IMAX Darling Harbour

*State Significant
Development
Modification Assessment
(SSD 7388 MOD 6)*

December 2018

Figure 4 | Building envelope comparison showing approved (purple) and proposed (red) (source: Applicant's RtS).

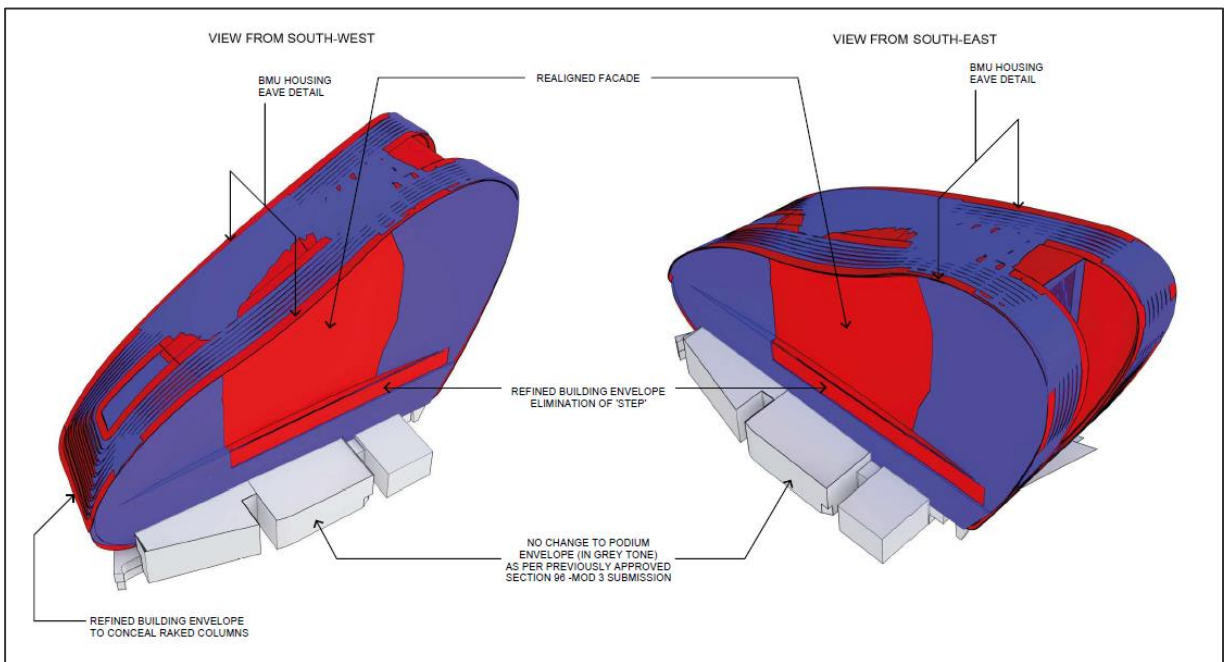
The modified building form features various increases and reductions around the edge of the undulating curved shape, whilst effectively maintaining the shape of the approved building. The largest increases are to the lower western edge of the tower where the building curve extends between 3 and 3.7m (**Figure 11**) and the projection of the BMU rail from the perimeter façade between 1.2 and 1.7m (**Figure 13**).

The Department considers the proposed changes to the tower form to be minor in the context of the overall development. The tower form would continue to provide an undulating curved shape, maintaining the integrity of the original design concept and would not result in any additional impacts in terms of overshadowing or affect any sensitive views of the site. The proposed changes would not result in additional height, or overall increase in bulk or massing, with the variances to the curved shape of the facades being largely imperceptible. The modified building envelope also maintains the required minimum setbacks to RMS assets of the Western Distributor road deck and supporting columns.

Subject to submission of a revised wind impact assessment, the Department considers the amendments to the tower form and massing are acceptable.

Figure 5 | CGI of approved west elevation (top) and proposed west elevation (bottom) (source: Applicant’s EA).

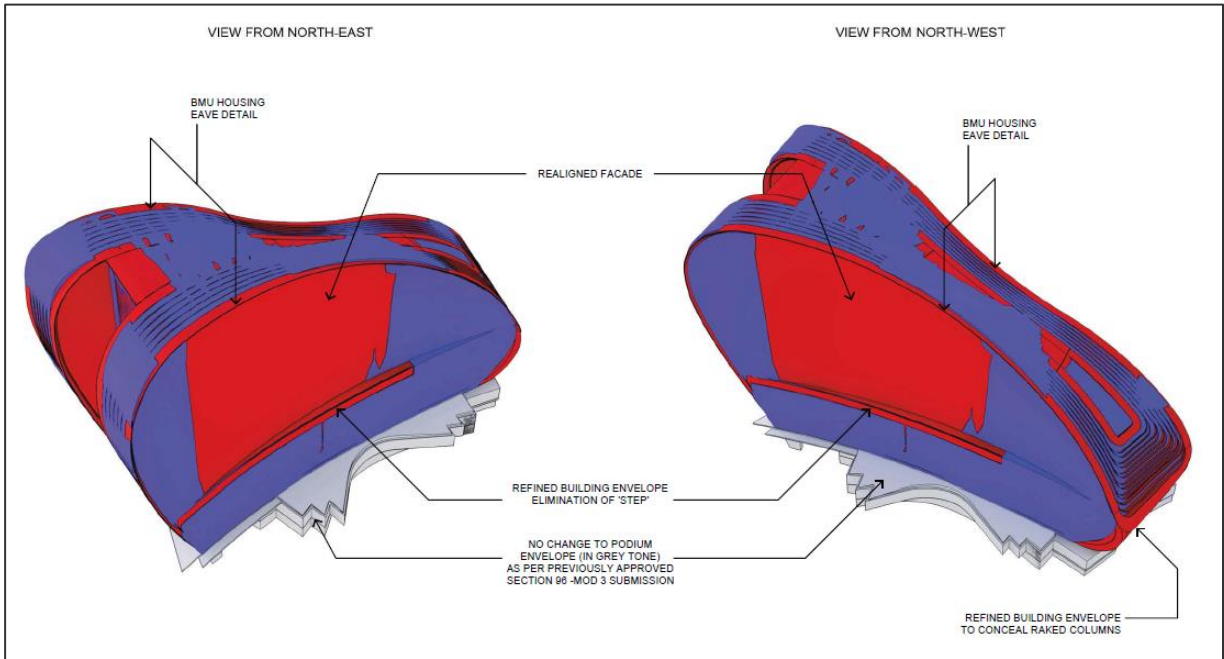
The key external changes to architectural detailing and materials (appearance) are the incorporation of the BMU railing around the perimeter of the tower, new aluminium clad vertical louvres (**Figure 5**) and amendments to the façade glazing pattern to smaller 2m x 2m panels (**Figures 6 & 7**).

The Applicant advised that the proposed vertical louvres have been incorporated to improve solar shading and provide additional privacy to the hotel and serviced apartments, whilst the 2m x 2m glazing panels have been designed to facilitate future glass maintenance and replacement above the Western Distributor.

The Department considers that the proposed vertical louvres and revised glazing pattern are an acceptable design solution, which compliments and enhances the original design concept. The proposed inclined louvres respect the curved form of the tower envelope, and further emphasise the lateral movement and flow of the tower design in elevation. The integrated BMU rail is incorporated into the louvre design and is considered to represent a superior design outcome compared to a separate non-integrated railing.

The Department therefore considers that the proposed changes to architectural detailing and materials would maintain the design integrity and appearance of the original proposal and are therefore acceptable.

Figure 8 | Approved ground floor layout (top) and proposed ground floor layout (bottom) (source: Applicant's RtS).

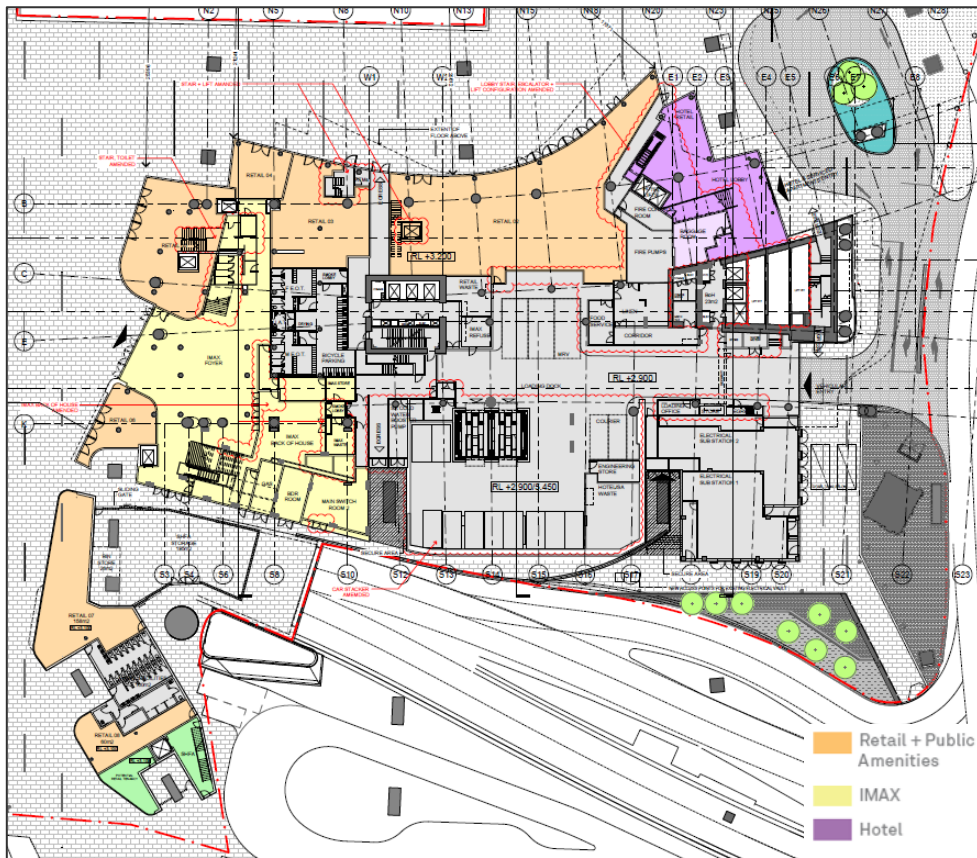
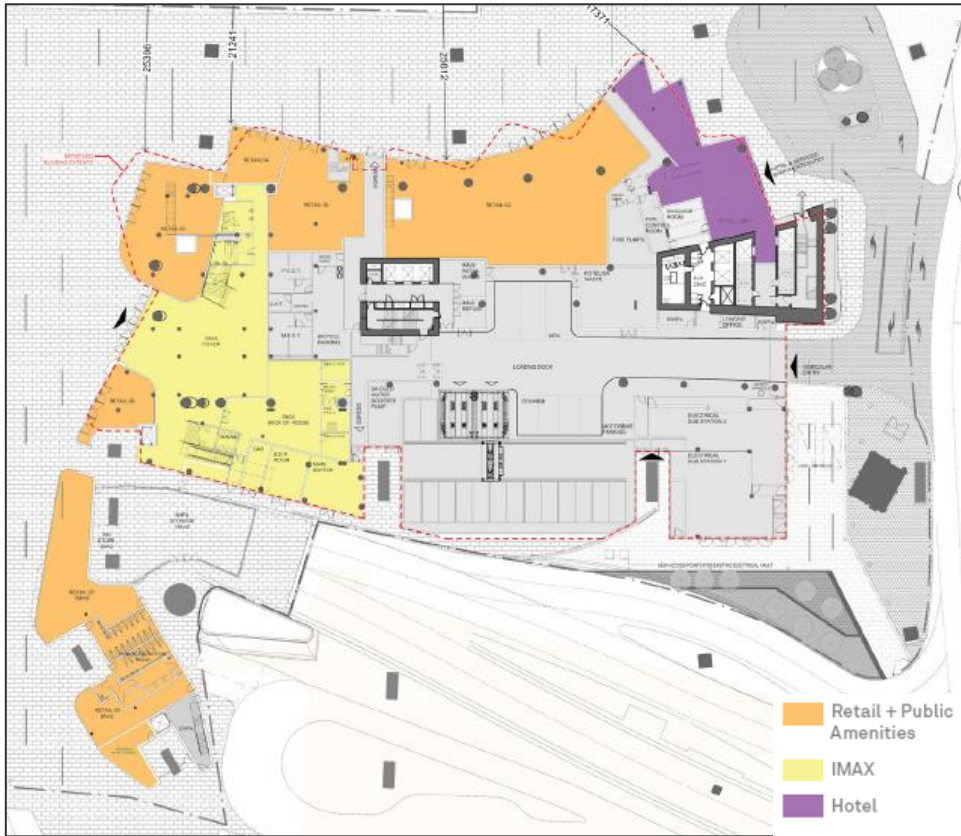
The proposed internal changes at podium level are the result of detailed design development and the rationalisation of back of house, storage and circulation spaces. This reconfiguration results in a minor increase in retail and cinema floorspace at ground and podium level. However, the changes are internal and will not impact the amenity of the surrounding area.

The Department considers the proposed internal changes are minor in the context of the overall development. The location, layout and proportion of uses remains largely consistent with the original approval and compatible with the character of Darling Harbour as a tourist and entertainment precinct.

Figure 10 | Proposed signage zones (source: Applicant's EA)

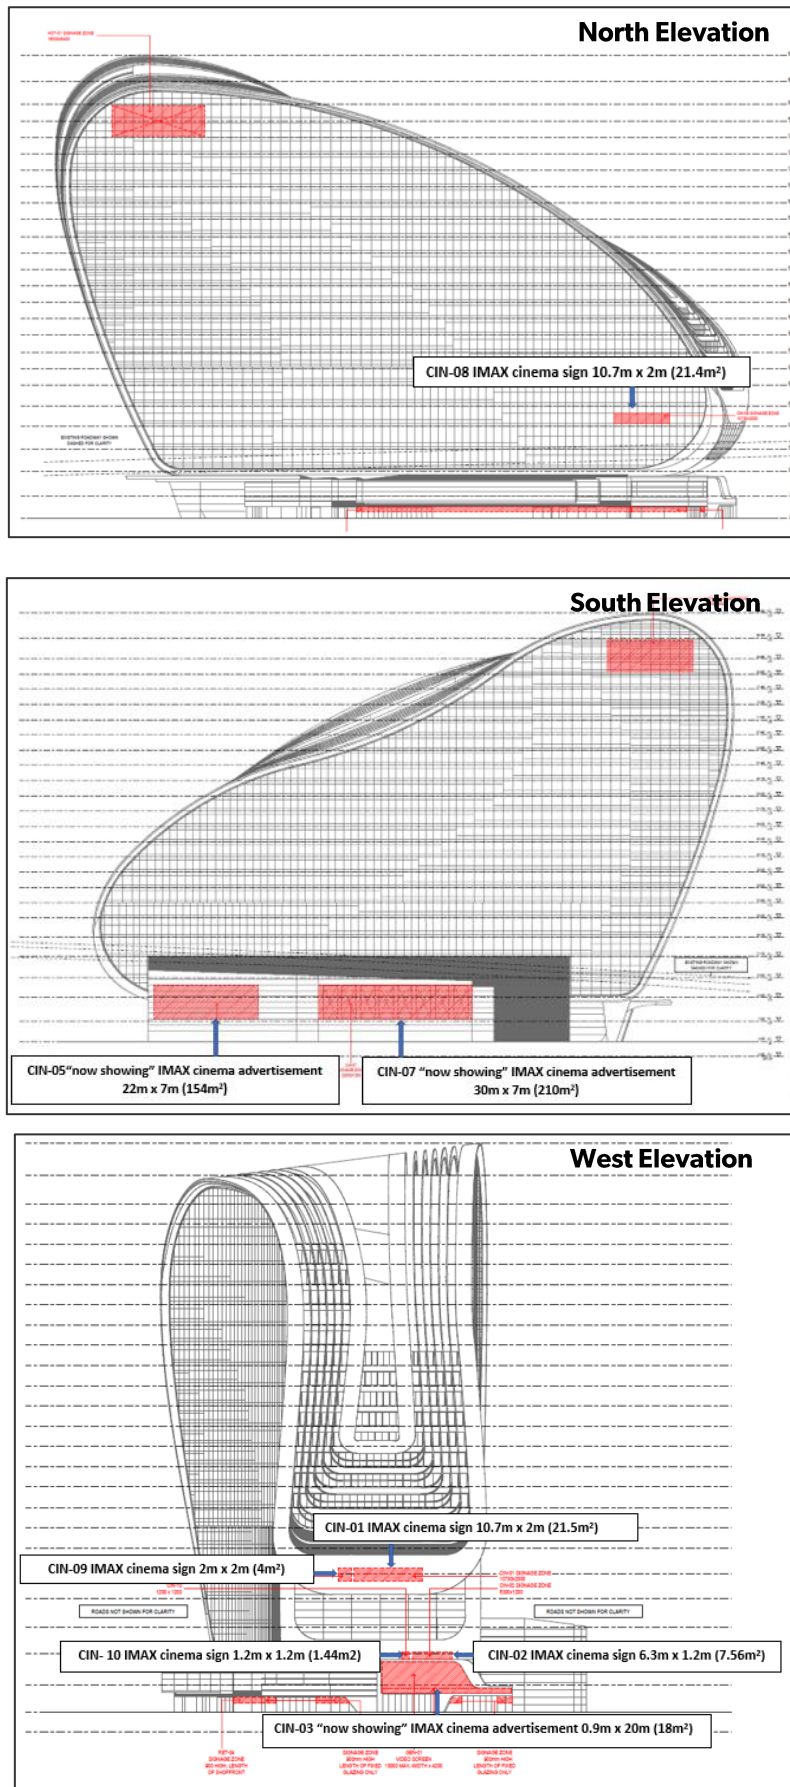
The modification proposes eight additional signage zones (**Figure 10**) and revisions to 13 approved signage zones for business identification (to allow for changes to the podium approved under SSD 7388 MOD 3). The proposed additional signage zones are shown in **Table 6** below. An assessment of the proposed signage zones against the assessment criteria in SEPP 64 is included at **Appendix B**.

The proposed eight new signage zones are of a similar size and location to the signage zones proposed as part of the original application. However, during the original assessment nine signage zones were withdrawn from that application following concerns raised by the Department in relation to:

The Department considers the proposed business identification signage zones for the IMAX cinema (CIN-01, 02, 08, 09 and 10) are well integrated into the lower northern and western facades and are reasonable in the context of the overall height and scale of the building. The Department notes that although multiple signage zones are proposed on the western elevation, this elevation is split between the tower elevation above the road deck and the podium elevation below, ensuring the signs will be read separately (by motorists above and pedestrians at ground level) and would not result in visual clutter. The location of signage within these zones will not obscure or obstruct any existing views or detract from the character of building, surrounding buildings, or the amenity and visual character of Darling Harbour, which is typified by an active ground plane and a variety of building, advertising and wayfinding signage.

Figure 14 | View comparison of approved envelope (purple) and proposed envelope (red) (source: Applicant’s Visual Impact Assessment)

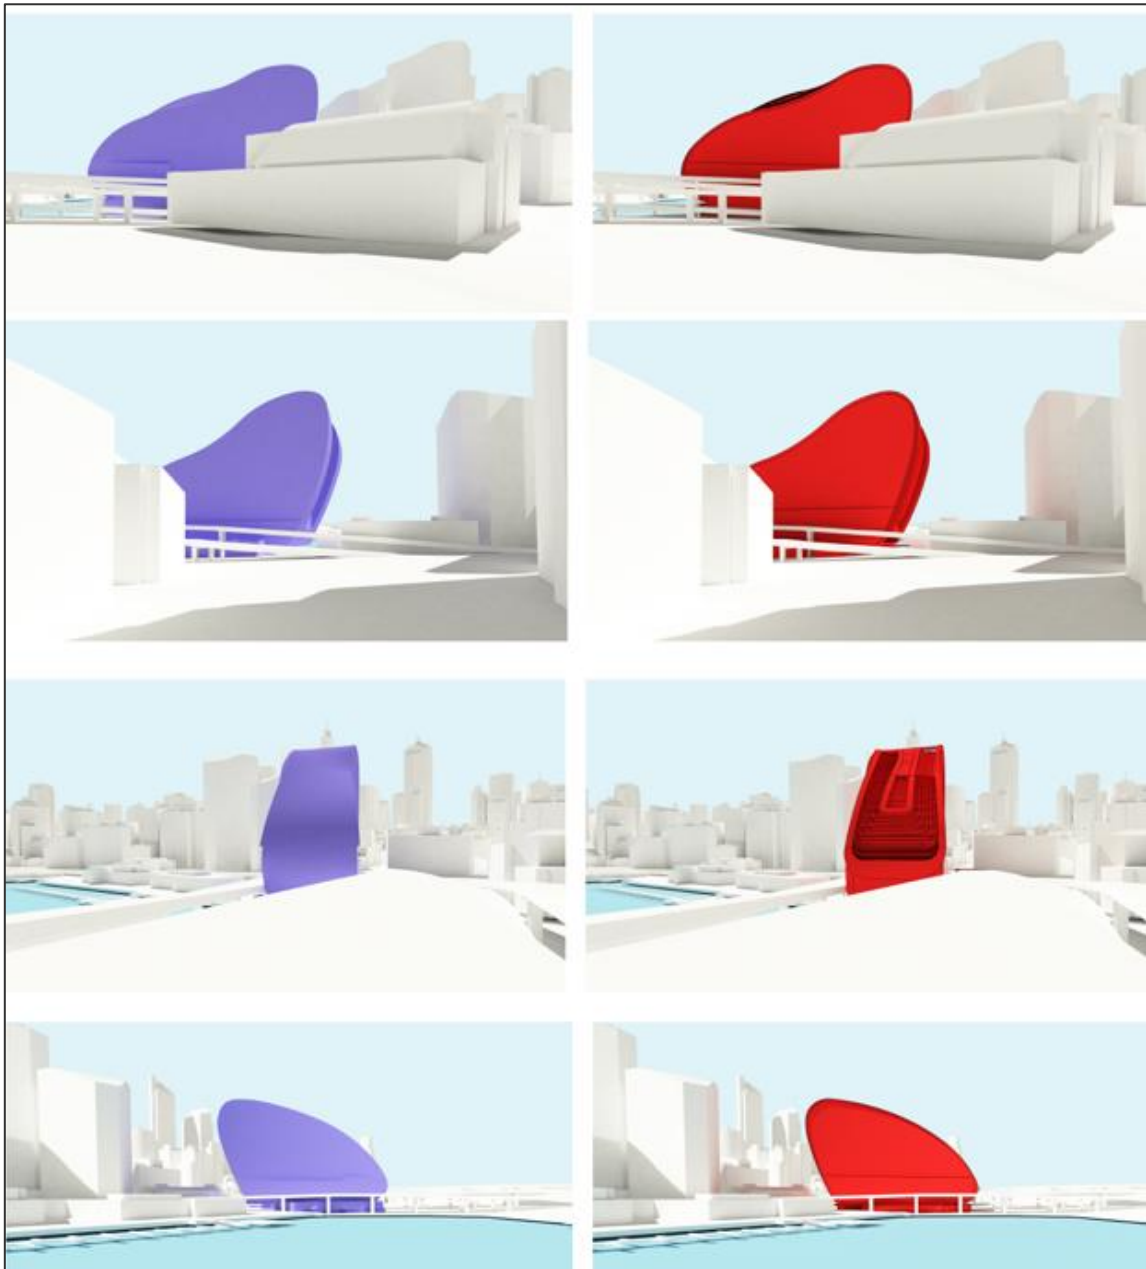
The proposed modified built form is largely consistent with the approved building and maintains the maximum height and general form, bulk and massing. The changes to the tower form and massing are shown in **Figures 4 to 10** and below (**Figures 11 to 14**).

Figure 15 | South west view of signage zone CIN-07 from ground level (source: Applicant’s RtS)

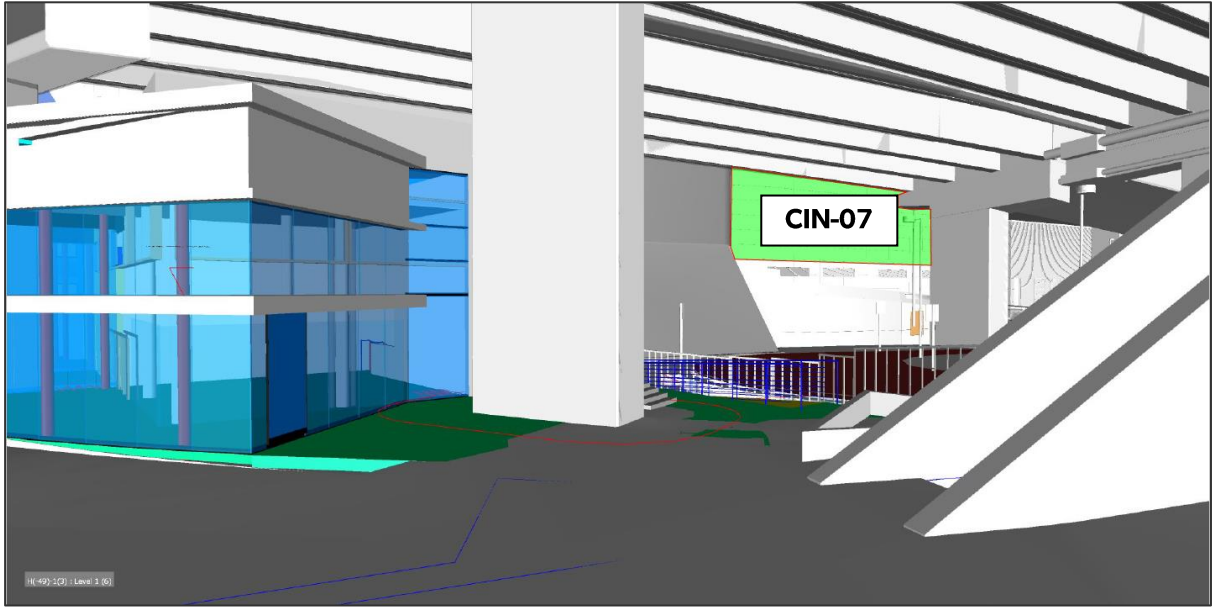
The “now showing” cinema advertisement zones (CIN-05 and CIN-07) are located on the rear southern elevation at podium level, below the road deck (**Figures 15 & 16**).

Although large, these advertisement zones are unlikely to result in harm to visual amenity of the public realm due to being heavily obscured by the multiple road decks of the Western Distributor to the south and located away from important views from Darling Harbour foreshore. The Department considers promotional “now showing” signage is appropriate for the cinema building and will add visual interest to the otherwise blank rear façade of the podium, whilst marking the location of the IMAX cinema to pedestrians approaching the site from the south.

Figure 16 | West view of signage zone CIN-05 from the road deck (source: Applicant’s RtS)

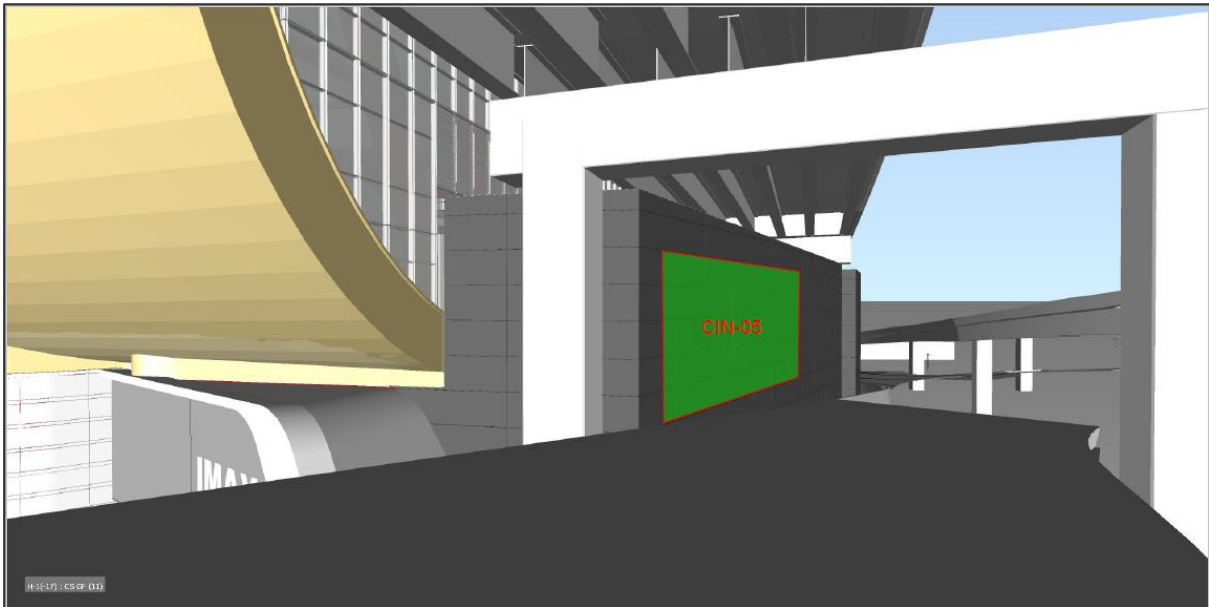
The modification application was referred to RMS in accordance the requirements of SEPP 64 and the Applicant submitted a road safety assessment in support of the proposed signage zones. The road safety assessment concluded that the proposed signage locations would not have an unacceptable impact on road safety. The Department notes that RMS raised no objection to the proposed signage zones however recommended that future advertising signage within zones CIN-05 and CIN-07, should comply with the Transport Corridor Outdoor Advertising and Signage Guidelines 2017 (due to their proximity to the Western Distributor). The Department therefore recommends that existing Condition E3 be amended to require future signage within zones CIN-05 and CIN-07 demonstrate compliance with these guidelines and subject to this condition, considers the location of the signage zones is acceptable with respect to road safety impacts.
